GROSVENOR | 4TH FLOOR SHIP CANAL HOUSE, MANCHESTER

FLOOR FINISHES / REVISIONS

RAISED FLOOR AMENDMENTS

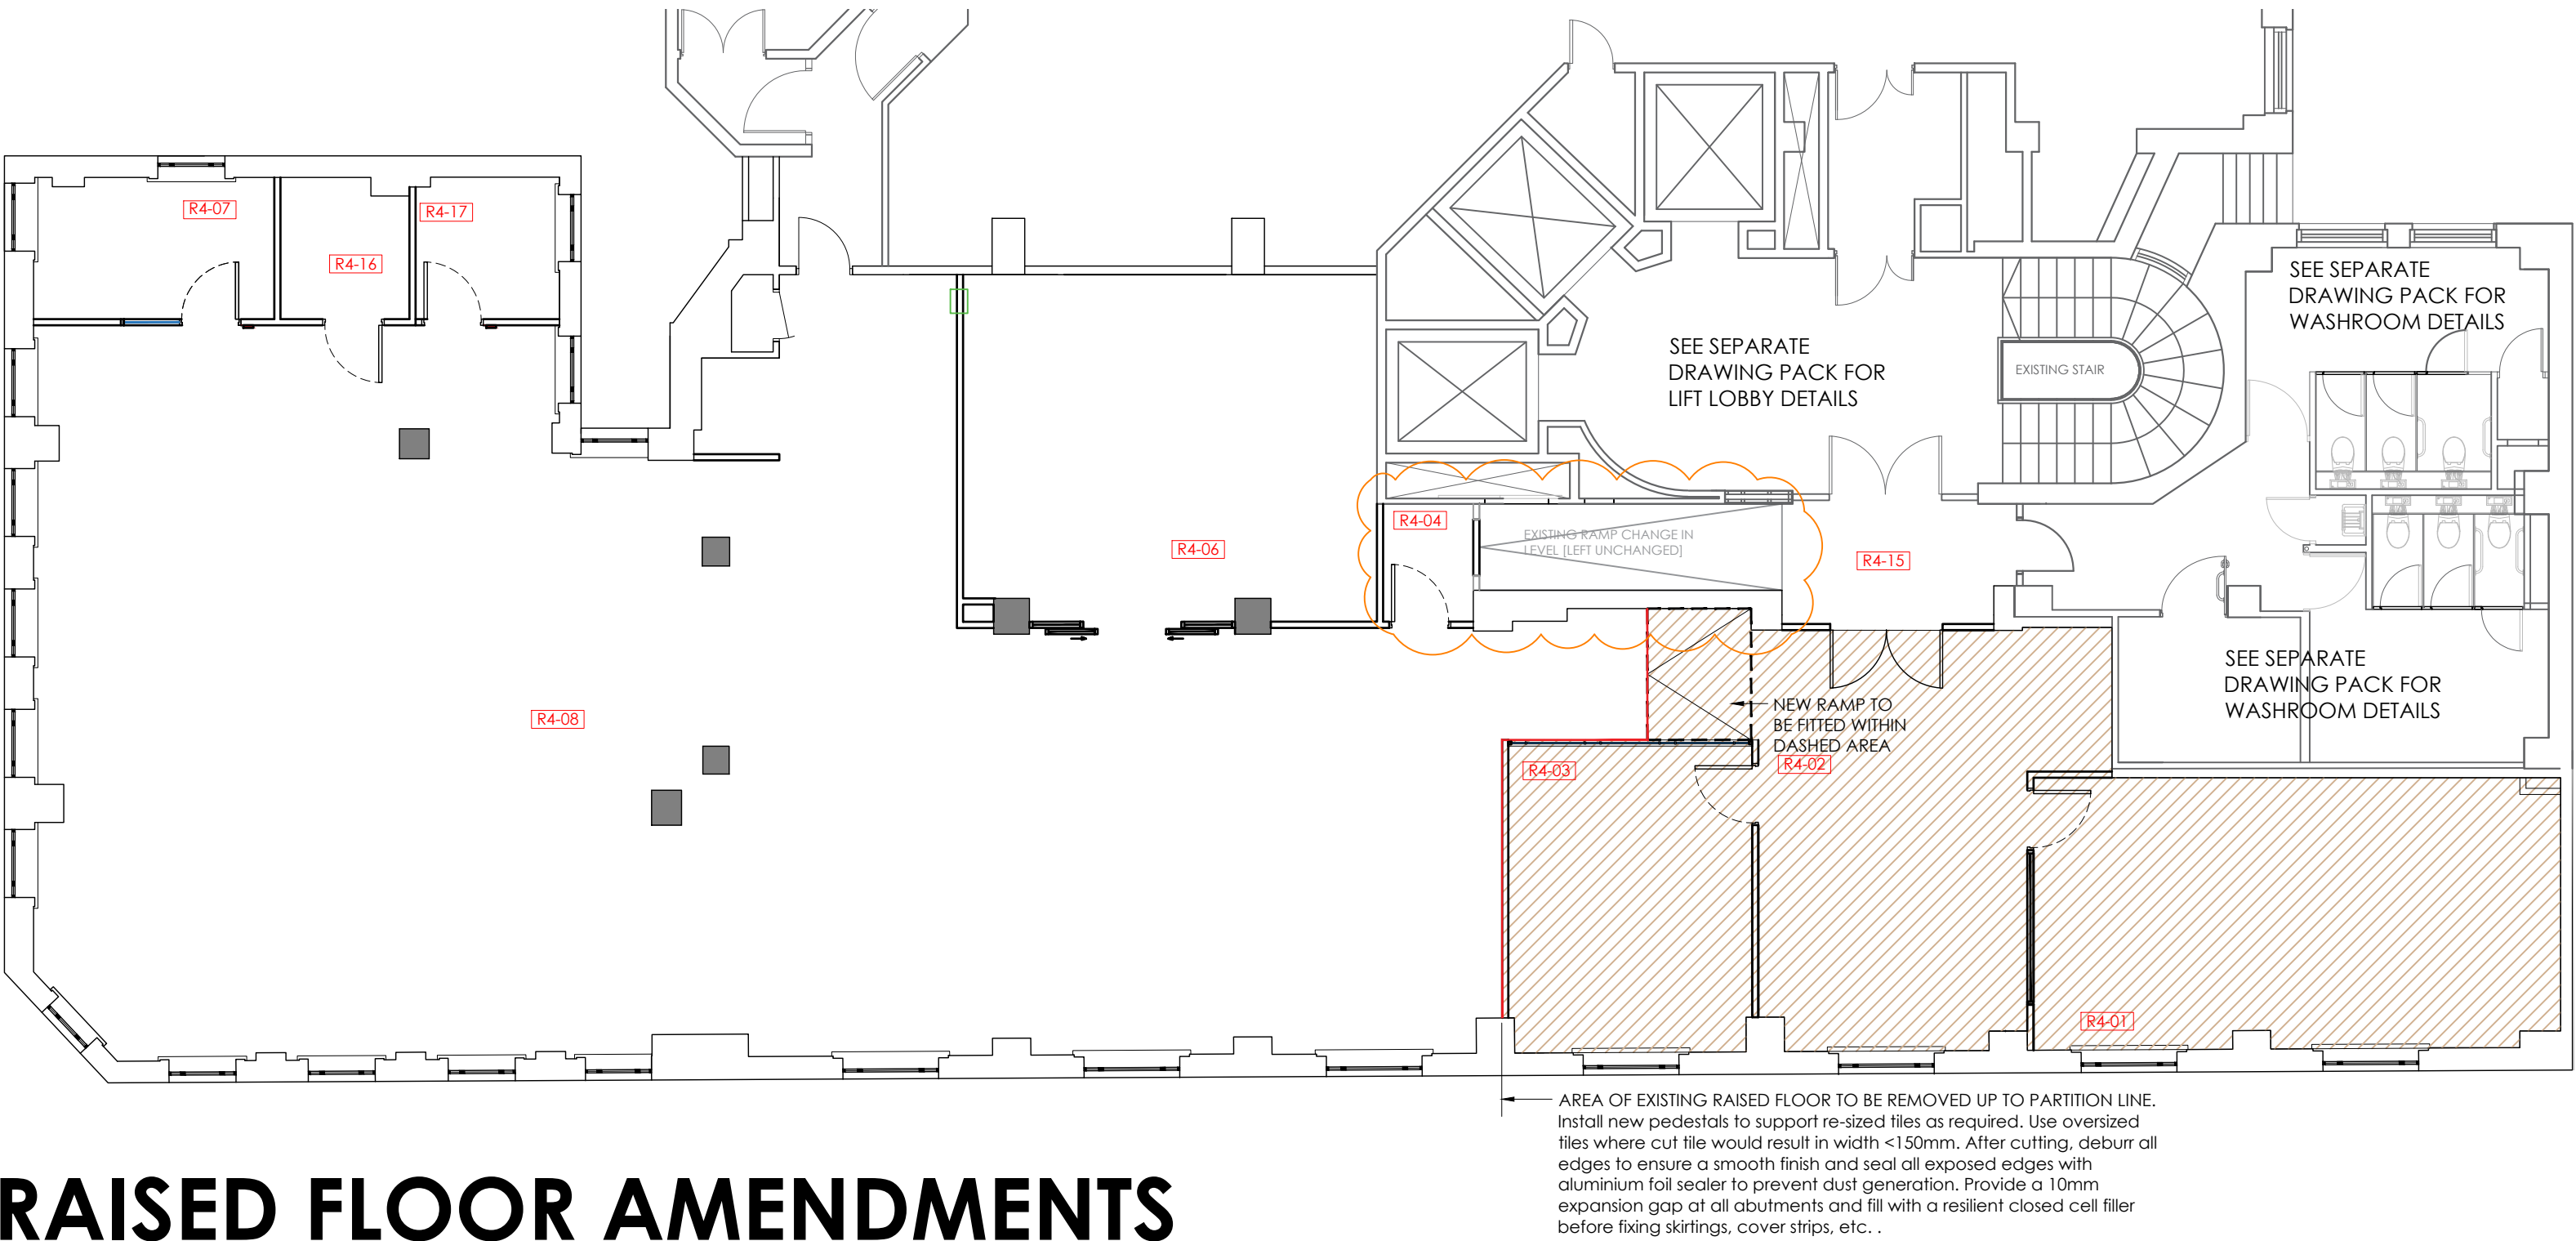
- AREA OF EXISTING RAISED FLOOR TO BE REMOVED.
Exposed slab to be made good to accept new carpet /
vinyl floor finish. Levelling screed to be applied as required
to ensure sound level finish.
- Construct ramp using proprietary raised access floor components: adjustable slope
pedestal heads; aluminium threshold top angle and aluminium rampshoe to transition
to the slab.

Ramp to be less than 1 in 20 gradient, thus avoiding ADK requirement for handrails,
change in floor finish etc. Raised floor height 80mm, therefore 1:21 gradient equates to
1680mm ramp

E	22.11.25	Ramp updates following heritage comments	FLC
D	10.11.25	Updated following heritage comments	HEK
C	26.09.25	Area amended to suit Litchfield requirements	CRH
B	07.09.25	Type G flooring omitted & washroom flooring spec amended. All flooring specifications now found on finishes schedule. FIRST FULL ISSUE FOR COMMENT	HEK
A	27.6.25		FLC
Rev	Date	Description	By
Client		GROSVENOR	
Project		4TH FLOOR SUITE	
Address		SHIP CANAL HOUSE	
Drawing Title		FLOORING LAYOUT	
Date		26.06.2025	
Scale		1:100 @A1	
By		FLC	
Drawing No		1427-04-FL-01(E)	
Status		FOR COMMENT
